MEMORANDUM

TO: Robert Ford, CIH, CSP **HSM-17006**
 Environmental Program Manager I (No. assigned after issuance of memo)
 Worker Health and Safety Branch

SUBJECT: RECOMMENDATIONS CONCERNING THE CONSTRUCTION OF A
 FUMIGATION CHAMBER AT A PROCESSING FACILITY IN
 STANISLAUS COUNTY

Figure One: Site Layout. Orange: New Chamber, Blue: Existing Chamber

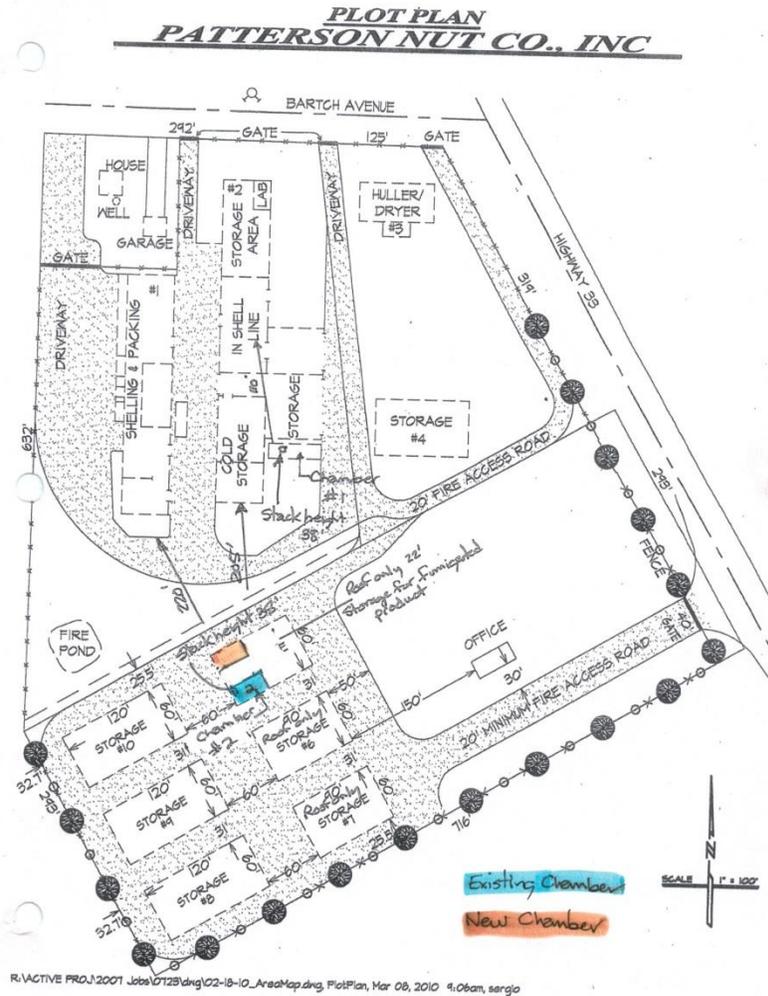
The issue under consideration was the construction of a new fumigation chamber adjacent to an existing fumigation chamber. Figure One shows the site layout and the location of both the existing chamber and the proposed site of the new chamber. There is another existing chamber (marked as “Chamber #1” on the site layout map), but it is not involved with any issues of the proposed new chamber.

The existing chamber (marked as “2” and highlighted in blue on the site layout map) has been fully permitted by Stanislaus CAC. The proposed chamber (highlighted in orange on the site layout map) would be under the same pole barn as Chamber 2 and would essentially be a duplicate of Chamber 2. Our walk-around of Chamber 2 did not uncover any obvious issues that were non-compliant with the Department of Pesticide Regulation’s “Suggested Permit Conditions: Methyl Bromide Commodity Fumigation 1994” (“MBr Permit Conditions”) document.
